**Coal Combustion Waste Impoundment
Round 7 - Dam Assessment Report**

Lansing Energy (Site # 11)

Alliant Energy
Lansing, Iowa

Dewberry & Davis, LLC
Fairfax, Virginia

Figure 7.2 Static Conditions modeling using SLOPE/W

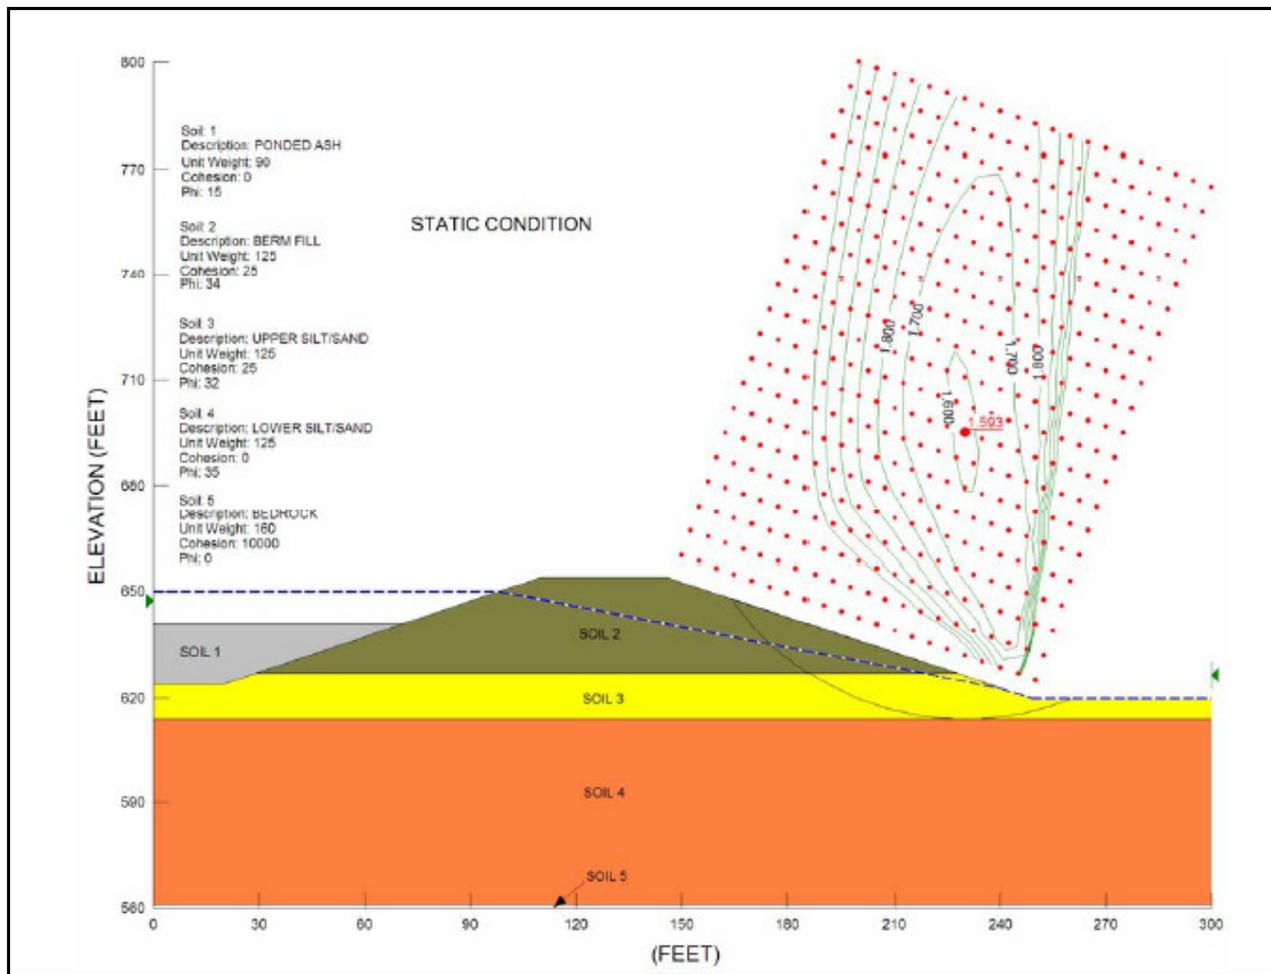
The technical documentation provided to Dewberry is adequate to estimate the three failure modes for the dike located under Power Plant Road. Similar analysis should be completed along the berm located along the western portion of Ash Pond 1.

DRAWING NO.
 S-14

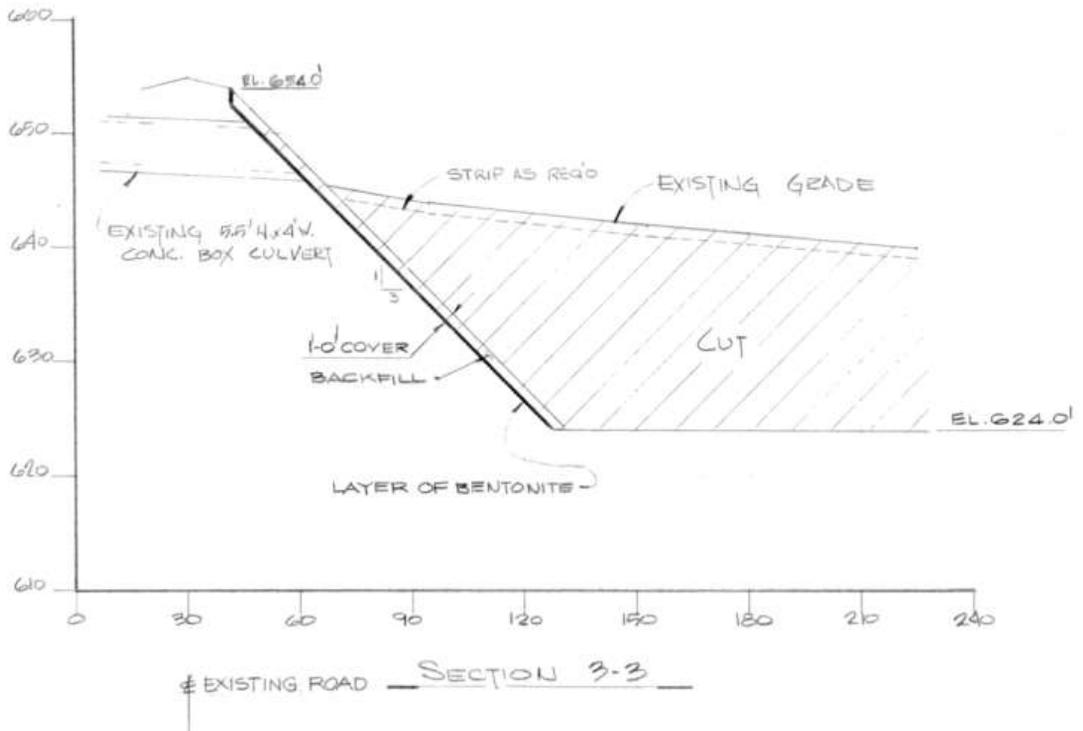
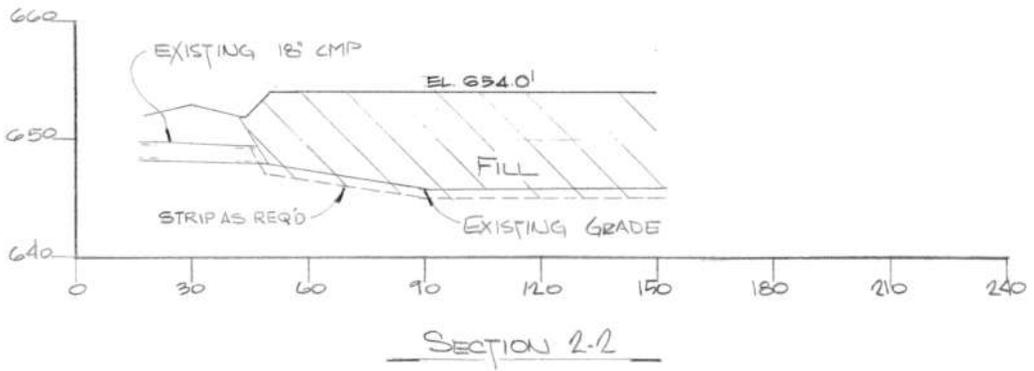
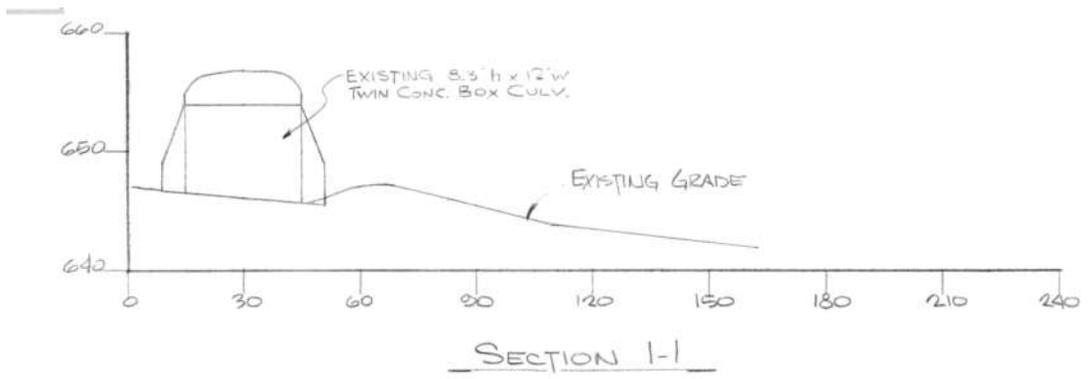
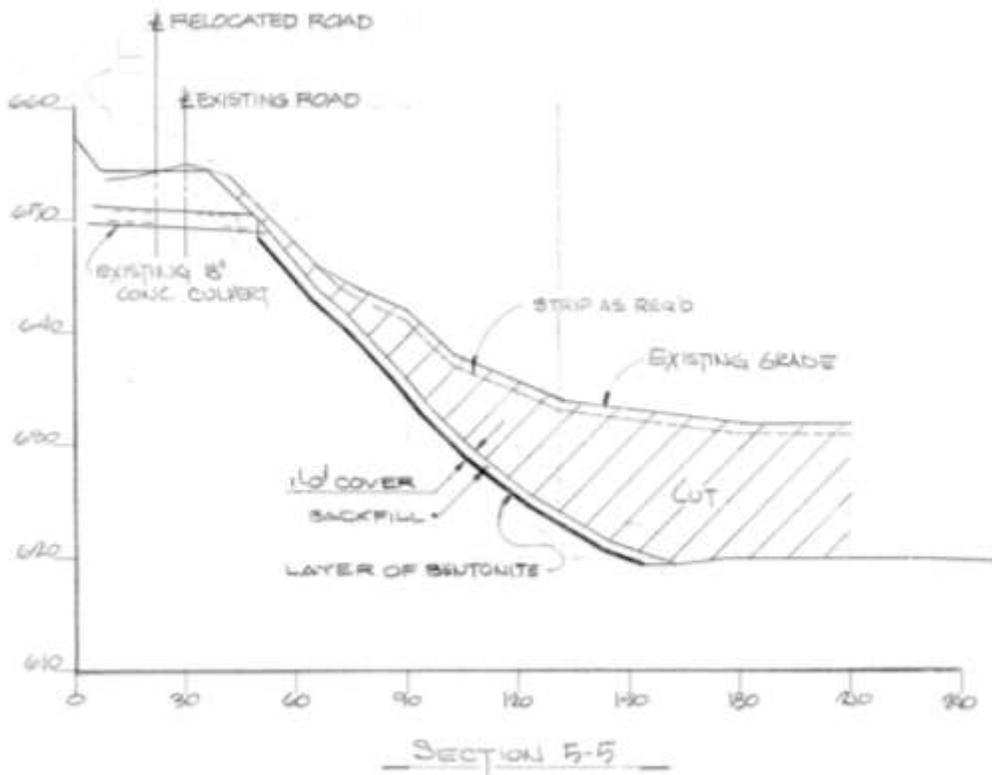
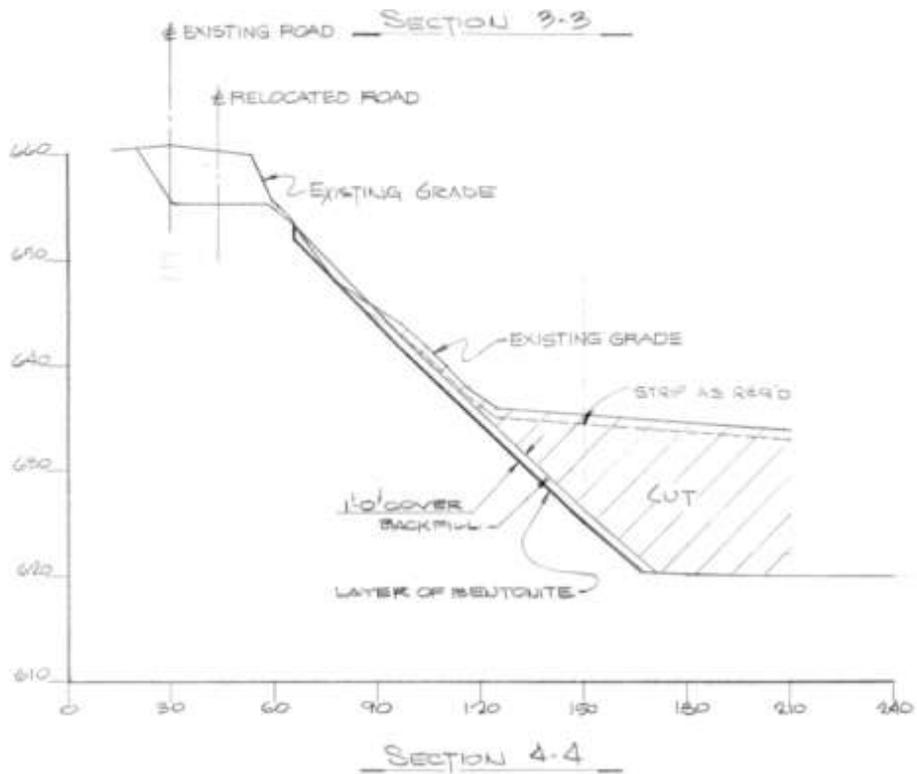
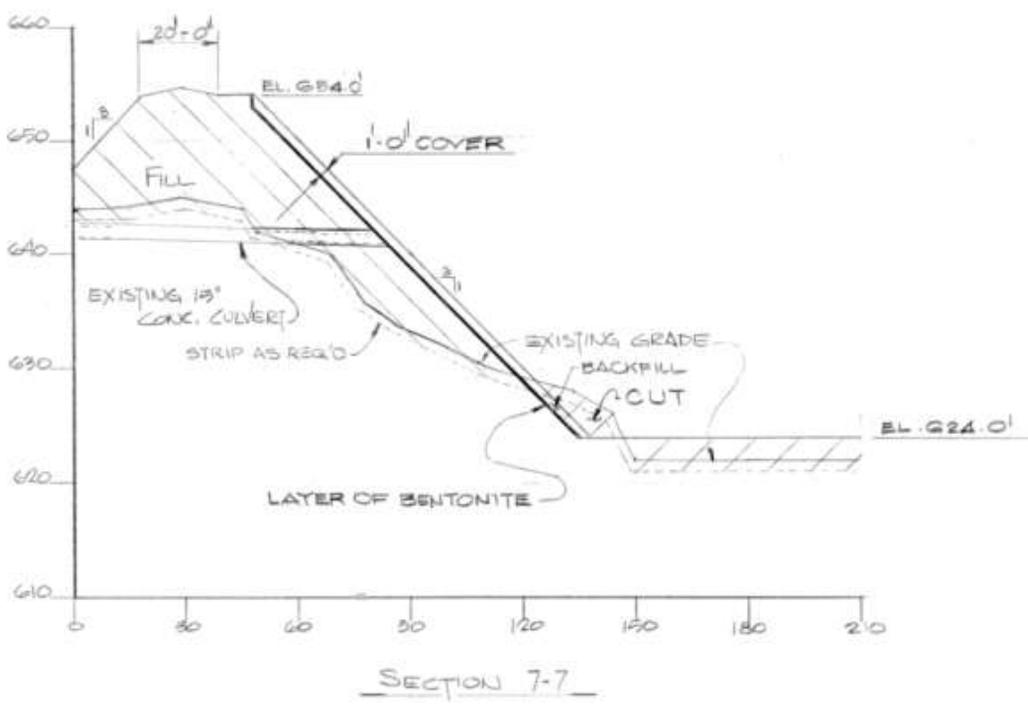
More recent survey than the 1976 construction plans would have been more accurate and should have been provided, including recent elevations of the pond

dikes and adjacent topography. The 1976 construction plans do not show some of the pond features, i.e. the southern half of Ash Pond 1 is channelized, yet the 1976 drawings do not reflect that alteration.

Picture 1.40
Pond 1 West outside dike Looking north

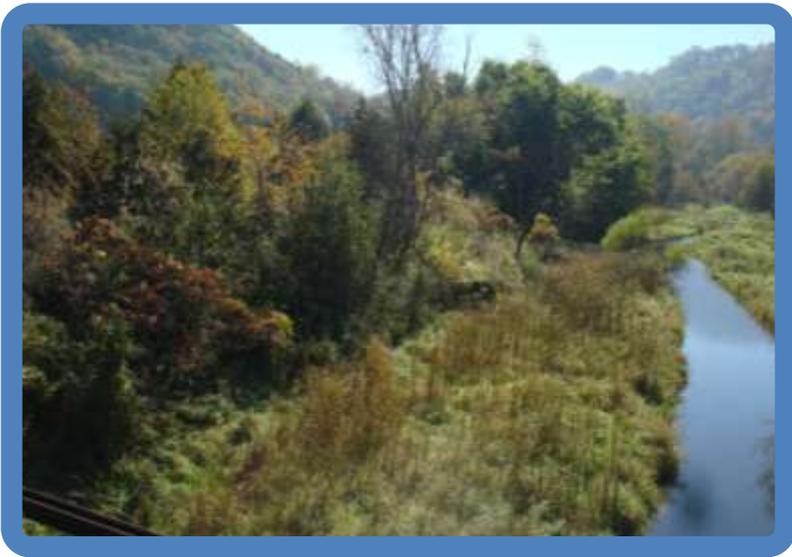
Removal of the trees and brush vegetation along the Ash Pond 1 west outside dike should be completed within a year and proper vegetative plants should be introduced. Alliant recommended the same tree removal action in their internal April 29, 2009 GENCO Standard inspection Guide document.

Alliant should provide structural stability analysis for the Ash Pond 1 west dike. This dike has a 30 foot height as measured from the outside toe to the crest. There are many 2-6 inch trees and other vegetation on the dike that need to be removed. The Ash Pond 1 west dike is the highest of the Lansing Station dikes and failure of the west dike would discharge effluent into the Mississippi River.
